**FOSTORIA SPLASHPAD
ADA RESTROOM FACILITY
AND PUMP HOUSE**

KLEINFELDER JOB NO. 24001561.002A

ADDENDUM NO. 2

March 26, 2024

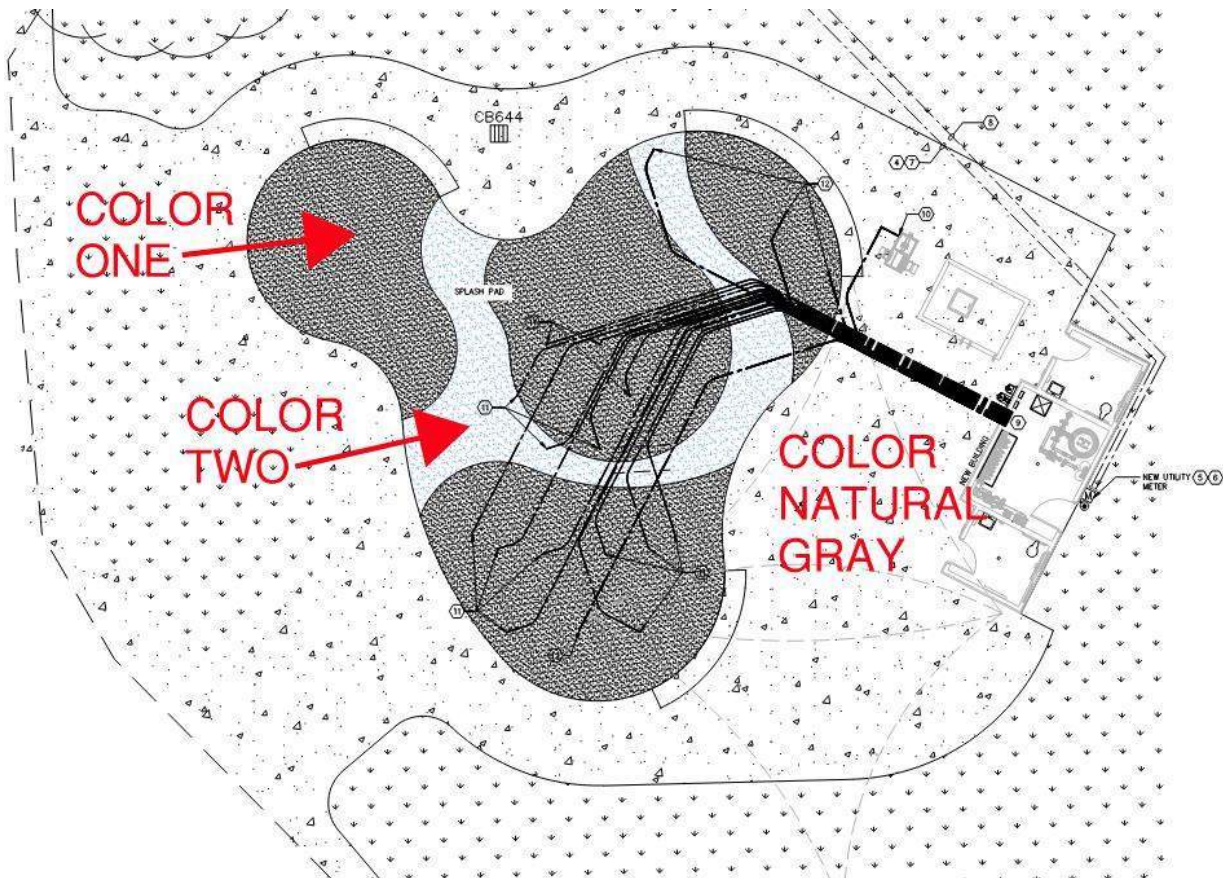
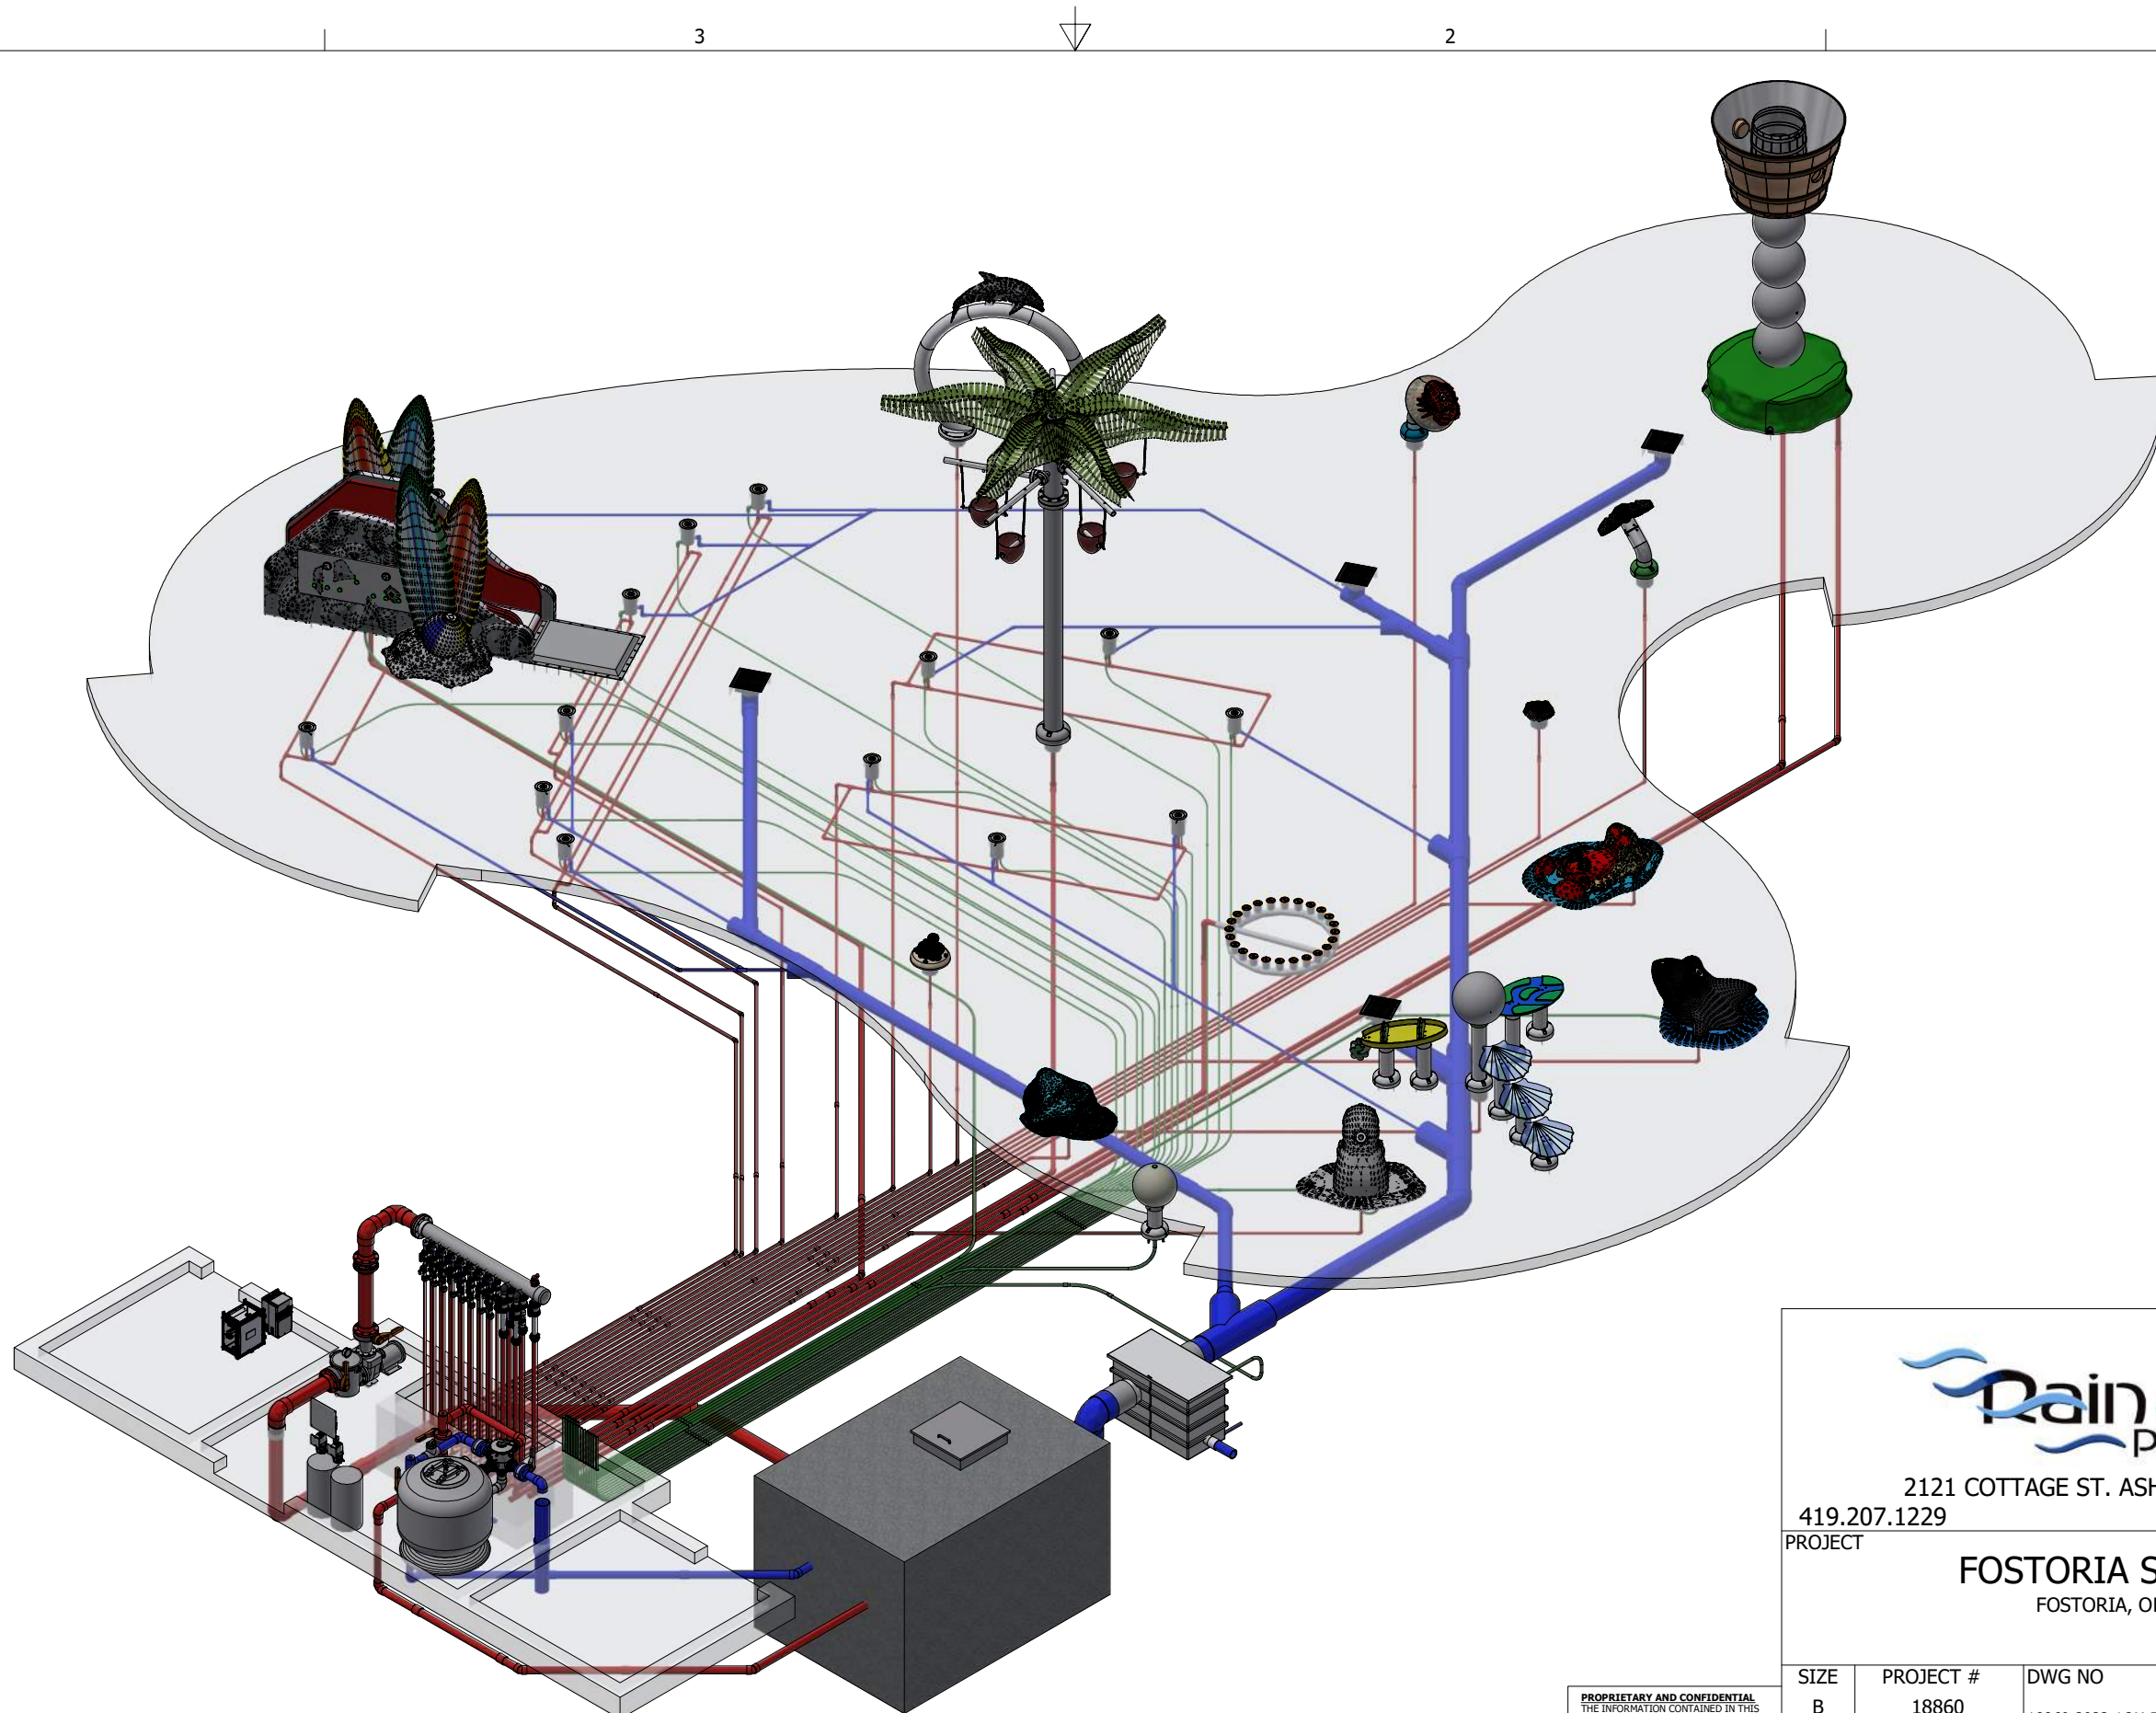
5. Question: Confirm the design criteria for the Splash pad concrete slab. *Response: The splash pad concrete is furnished and installed by the General Contractor. Final design and sawcut layouts will be coordinated with the final Splash pad delegated design. See attached Exhibit A for additional information.*

- b. Provide joint filler within all joints.
 - c. Fill to level of adjoining surfaces. See detail below.
8. Cold Joints: Joints between colored concrete in splash pad and joints between splash pad and adjacent concrete sidewalks shall be filled with joint filler.

9. Concrete Color: Two integral concrete colors. Plant mixed concrete. See below detail for further information.
 - a. Color selection by Owner from manufacture's standard color chart.
